UNITED STATES PATENT AND TRADEMARK OFFICE

APPLICATION NO.	FILING DATE	FIRST NAMED INVENTOR	ATTORNEY DOCKET NO.	CONFIRMATION NO.
09/680,277	10/06/2000	Je Hong Kim	2658-0242P	8486

Office Action Summary

DETAILED ACTION

FIG.4

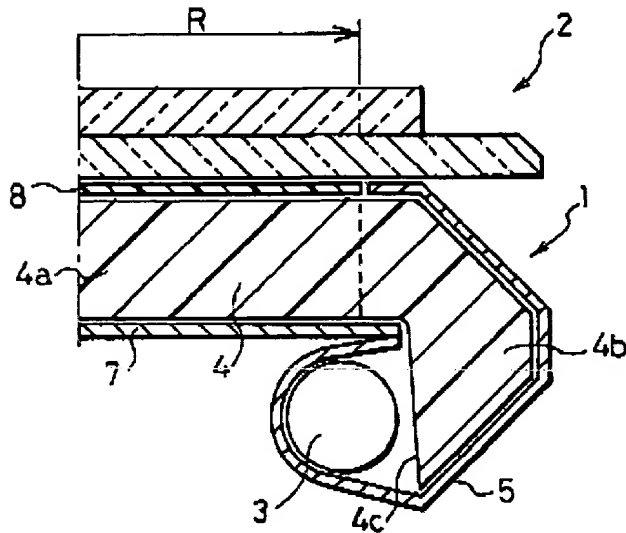
Oyama teaches in Figure 4 a light unit comprising a light-guide plate, 4a, and a reflector, 5, having a sectional view of spiral shape that efficiently guides the light

(Applicant's high focus) from the light source to the light guide plate (col. 6, lines 13-24).

Oyama is evidence that ordinary workers in the art of liquid crystals would find the reason, suggestion, or motivation to add efficient reflection (high focus) to reduce bright lines in the display near the light source (col. 13, lines 33-52, especially lines 42-48).

Oyama teaches in Figure 4 a light-guide plate, 4a, installed at height different from the light, 3, input to reduce the outside dimensions of the entire apparatus with respect to the area of the display space (col. 2, lines 53-60) having a sectional view of spiral shape.

FIG.14(b)

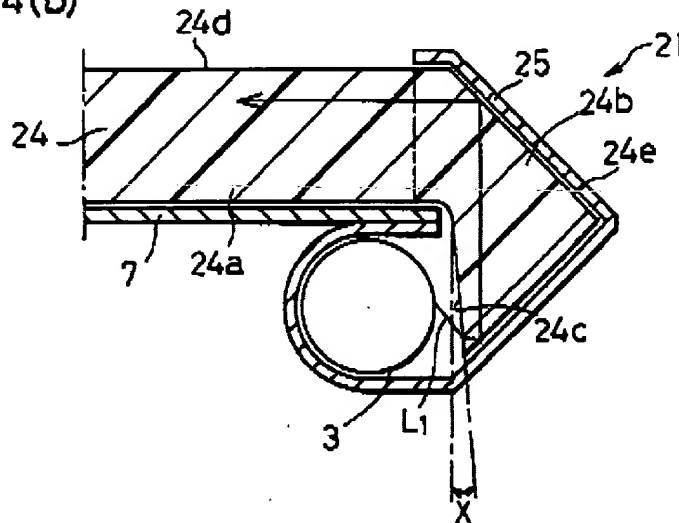
As to claim 5, Oyama teaches in Figure 14(b) a light unit wherein the reflective plate, 25, is curved to obtain a desired vertical incident angle of the light beam progressing to the light-guide plate to reduce bright lines in the display near the light source (col. 13, lines 33-52, especially lines 42-48).

Oyama is evidence that ordinary workers in the art of liquid crystals would find the reason, suggestion, or motivation to use a light unit wherein the reflective plate is curved to obtain a desired vertical incident angle of the light beam progressing to the light-guide plate to provide desired illumination characteristics.

FIG. 2

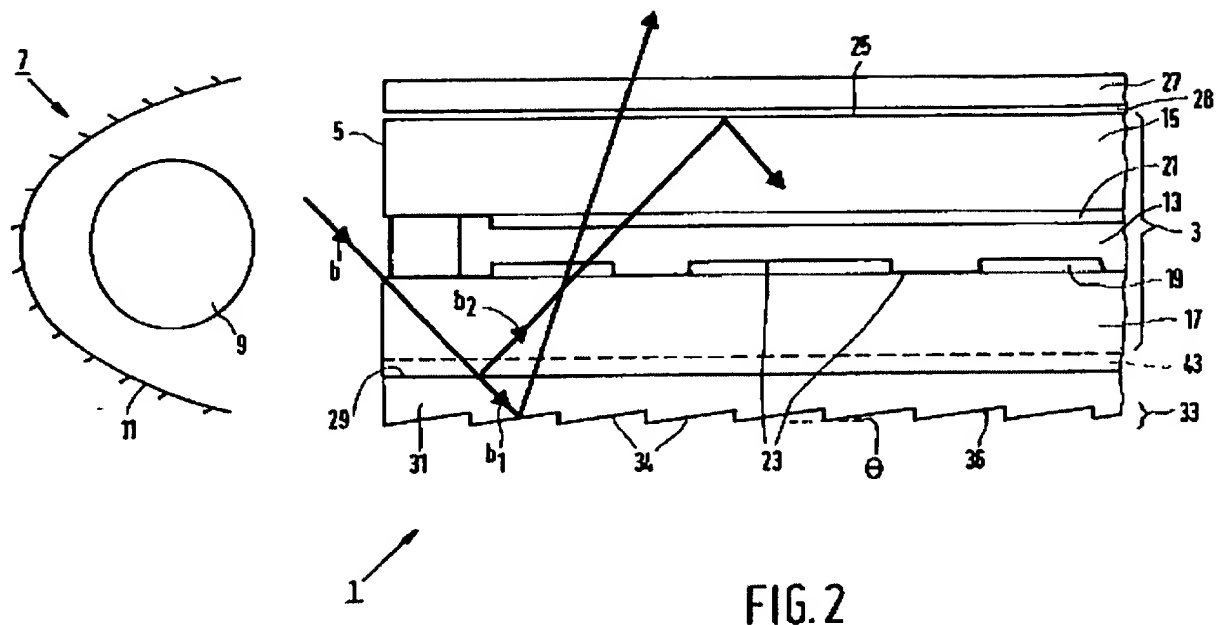
As to claims 8, and 11, Broer teaches in Figure 2 a light unit wherein the light-guide plate includes a plurality of unit patterns formed on one side thereof in parallel with the lamp, the plurality of unit patterns allowing the light beam from the lamp housing to be progressing perpendicularly into the liquid crystal panel.

Broer is evidence that ordinary workers in the art of liquid crystals would find the reason, suggestion, or motivation to use a light unit wherein the light-guide plate includes a plurality of triangular section unit patterns formed on one side thereof in parallel with the lamp, the plurality of unit patterns to cause the light beam from the lamp housing to be progressing perpendicularly into the [front of the (claim 16 only)] liquid crystal panel.

FIG. 7

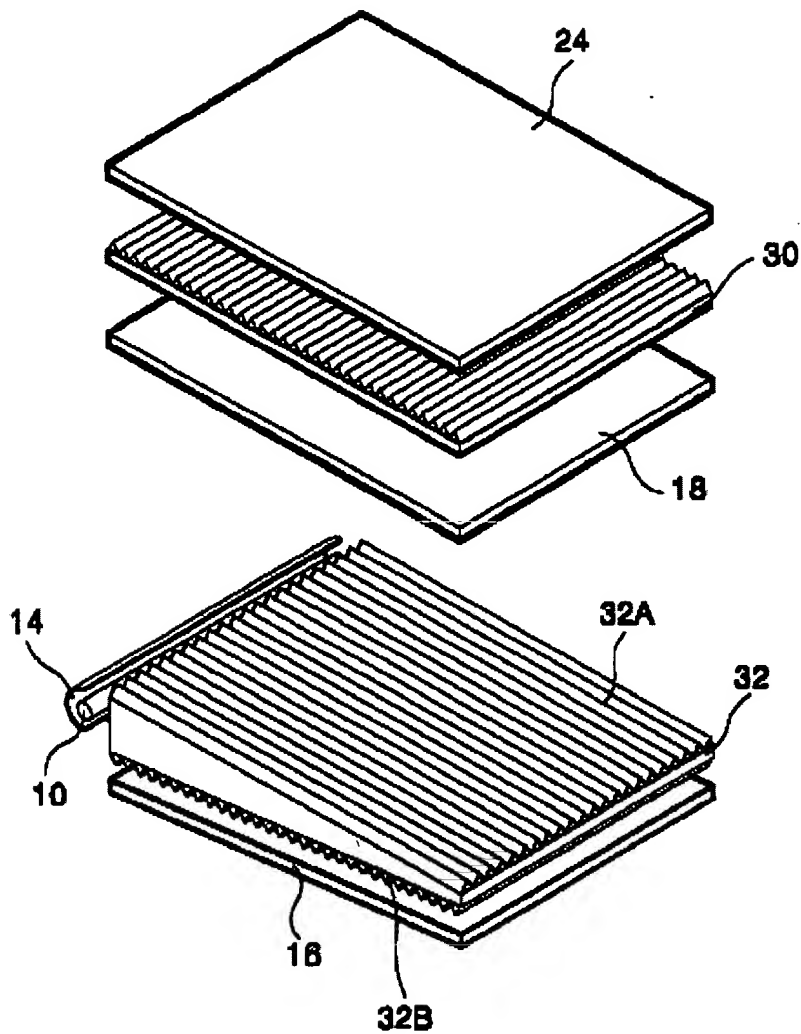
Kim teaches in Figure 7 the use of a light unit wherein the light-guide plate includes a plurality of prism patterns arranged on another surface thereof in intersection with the unit patterns.

Kim is evidence that ordinary workers in the art of liquid crystals would find the reason, suggestion, or motivation to add a plurality of prism patterns arranged on

another surface thereof in intersection with the unit patterns to enhance the utilization ratio of the light generated by the lamp (col. 6, line 58 through col. 7, line 15).

FIG. 1

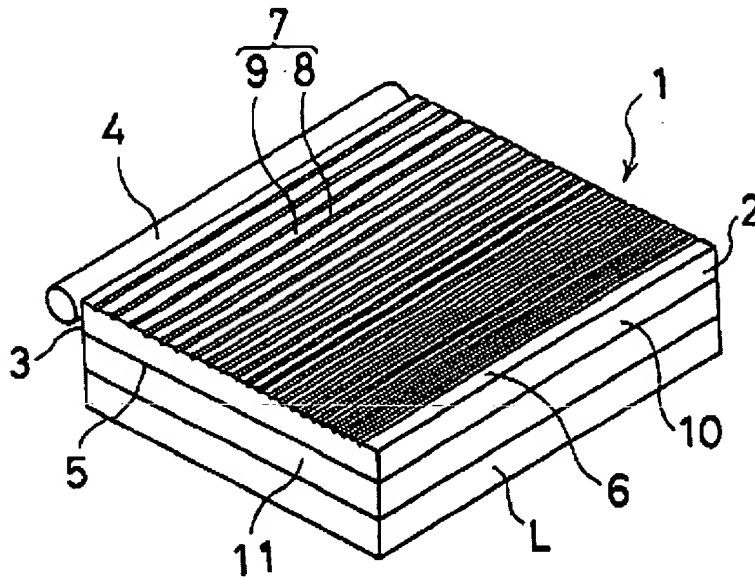
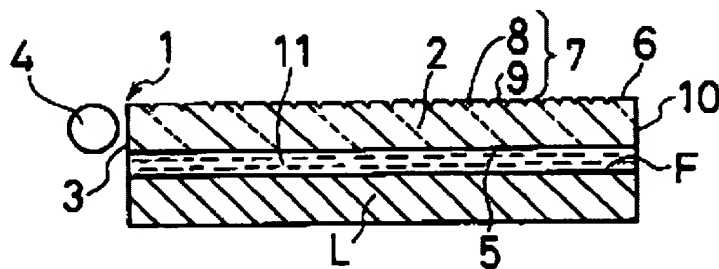
Egawa teaches in Figures 1 and 2 a light guide plate dispose on the front side of a liquid crystal panel to provide illumination without degrading contrast and without generating a moiré pattern (col. 4, lines 11-17).

Egawa is evidence that ordinary workers in the art of liquid crystals would find the reason, suggestion, or motivation to add a light guide plate disposed on the front side of a liquid crystal panel to provide illumination without degrading contrast and without generating a moiré pattern.

Egawa teaches in Figures 1 and 2 a light guide plate wherein a distance between the unit patterns that gets gradually shorter as said unit patterns get farther away from the incident side of the light-guide plate so that the brightness becomes nearly uniform at any position in the transparent substrate (light guide) without being influenced by the distances from the light source lamp (col. 12, lines 34-50).
